2. **Resolution No. 449. Twist Bioscience Storage Buildings.**

DB25-0008 Twist Bioscience Storage Buildings

Exhibit A1
Staff Report
Wilsonville Planning Division
Twist Bioscience Storage Buildings
Development Review Board Panel 'B'
Quasi-Judicial Public Hearing

PROPOSED FENCE TO MATCH EXISTING
6' HIGH WITH PRIVACY SLATS

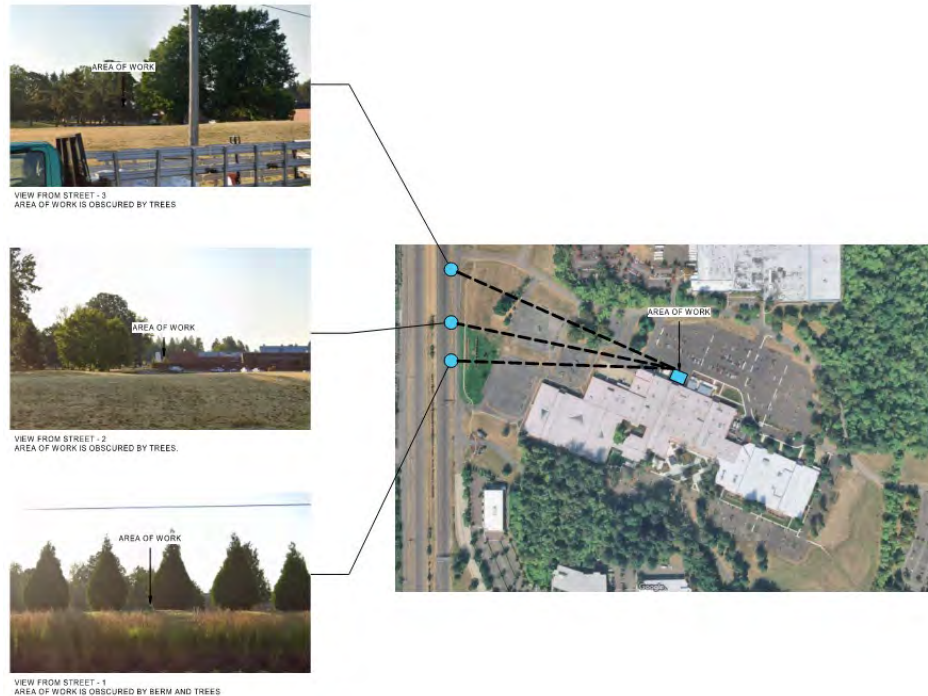
Partially Sight-Obscuring Fence Standard: The applicant proposes a six-foot, chain link fence with black privacy slats meeting the partially sight-obscuring fence standard along the proposed storage buildings and around the proposed loading area (Exhibit B2, Sheet A1.11). The proposed fence matches the existing, partially sight-obscuring fence around the adjacent outdoor storage yard.
